**FEDERAL AVIATION ADMINISTRATION  
AIRWORTHINESS DIRECTIVES  
LARGE AIRCRAFT**

**BIWEEKLY 2001-03**

## BW 2001-03

**Figure 1. Torque Values for PS3 Line Fittings**

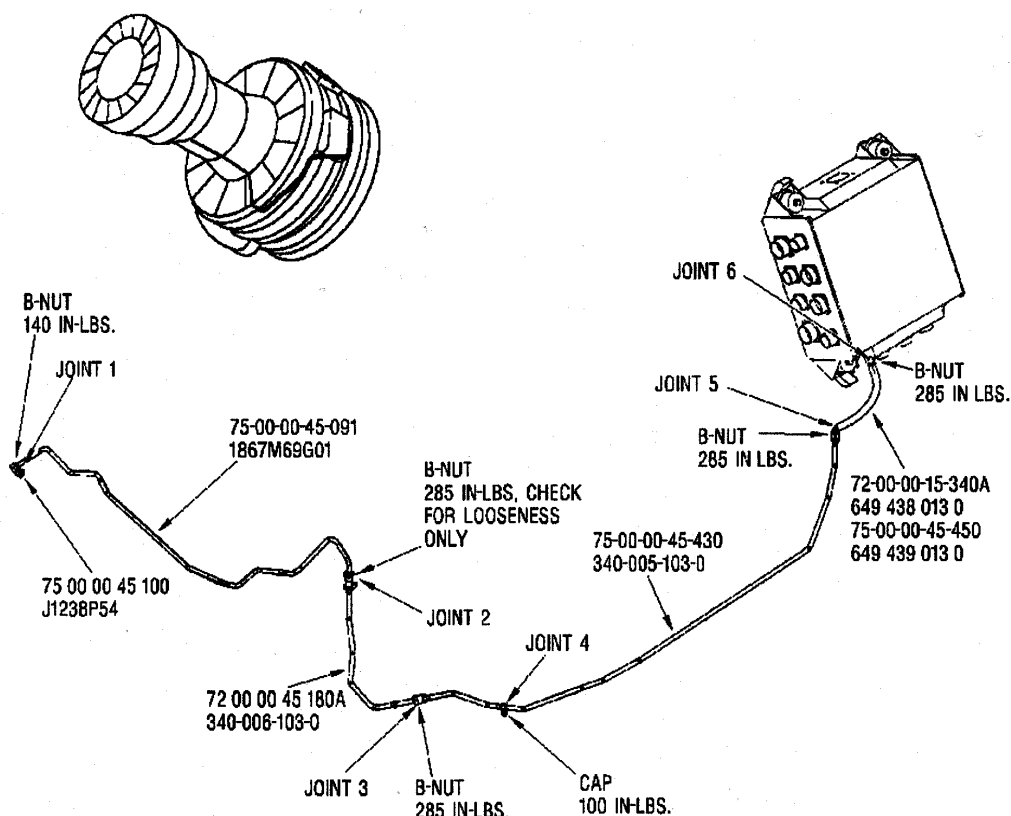
(a) Check for and apply the correct torque in the tightening direction of all PS3 pressure line fittings as identified in Figure 1 of this AD as Joint 1, Joint 2, Joint 3, Joint 4, Joint 5, and Joint 6 as follows:

- (1) Torque Joint 1 to ensure a torque value of 140 inch-pounds.
- (2) Due to accessibility limitations, check Joint 2 for finger looseness, and only if loose, torque to a value of 285 inch-pounds.
- (3) Torque Joint 3, Joint 5, and Joint 6 to ensure a torque value of 285 inch-pounds.
- (4) Torque Joint 4 to ensure a torque value of 100 inch-pounds.

Centre of Gravity Limits (MTOW 47,600 lbs)  
Figure 02-03-1

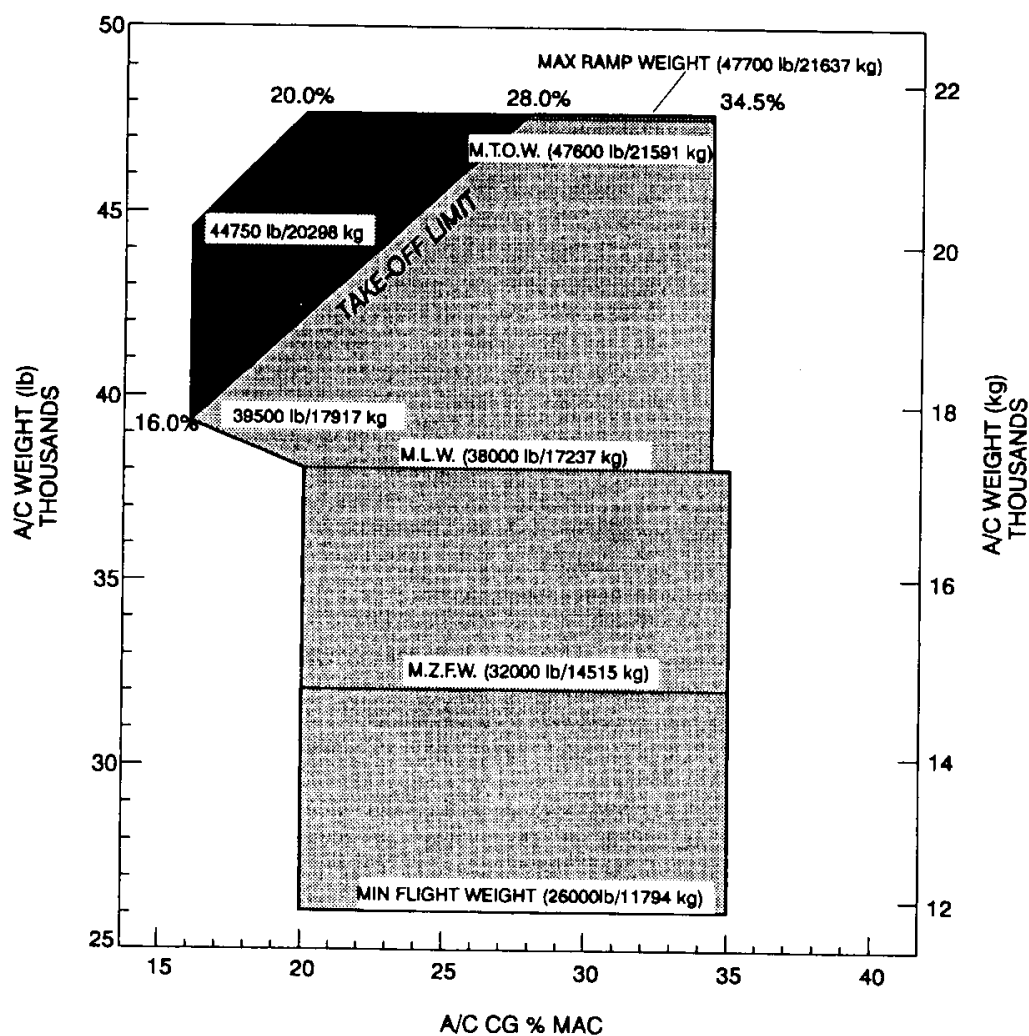
**REASON FOR ISSUE**

- Due to fuel migration under conditions of acceleration and/or climb, there is a possibility that the airplane may exceed the aft Center of Gravity Limit.

Pending rectification, replace figure 02-03-1 with the attached new figure 02-03-1.

Figure 02-03-2

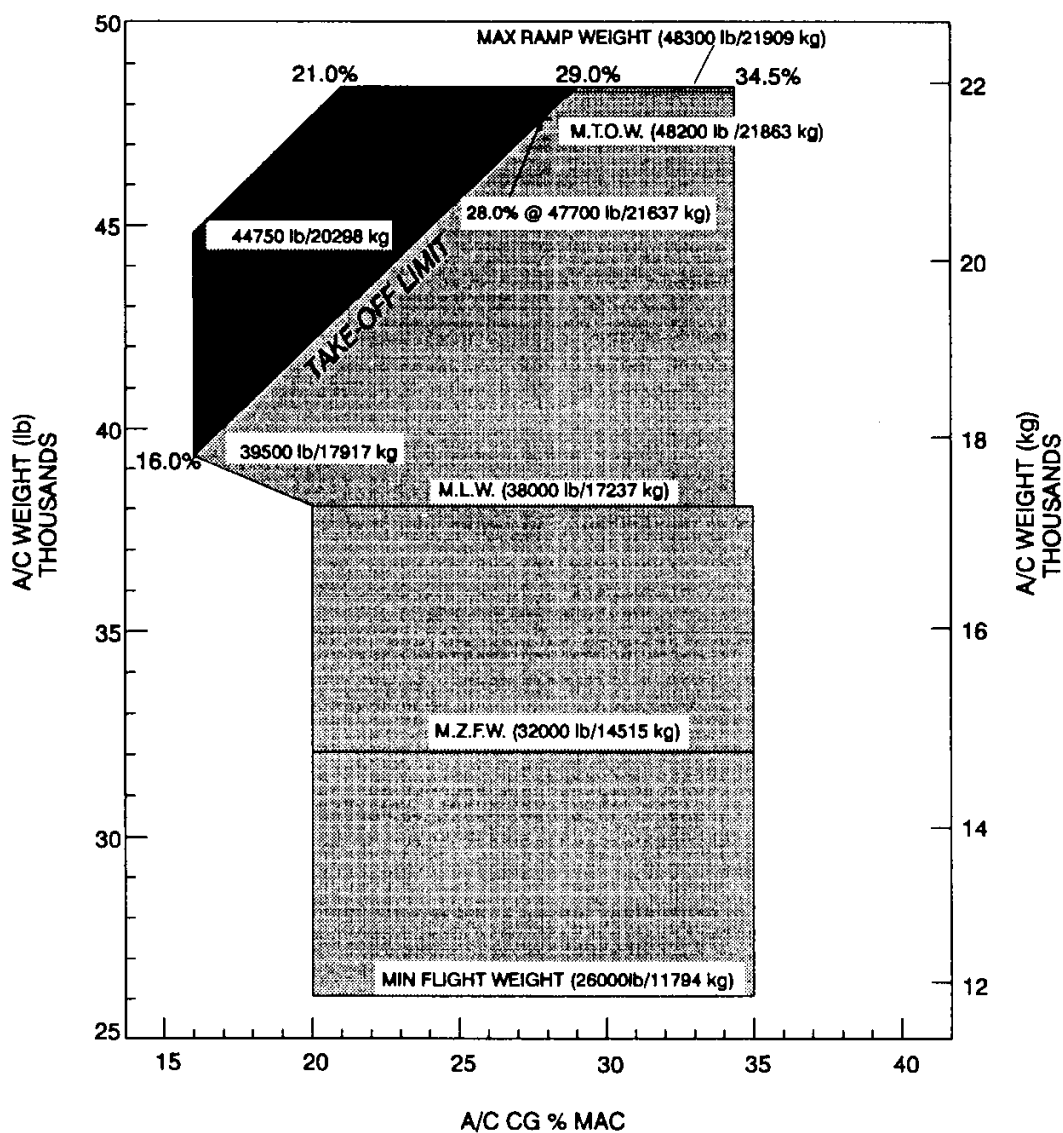
**REASON FOR ISSUE**

- Due to fuel migration under conditions of acceleration and/or climb, there is a possibility that the airplane may exceed the aft Center of Gravity Limit.

Pending rectification, replace figure 02-03-2 with the attached new figure 02-03-2.
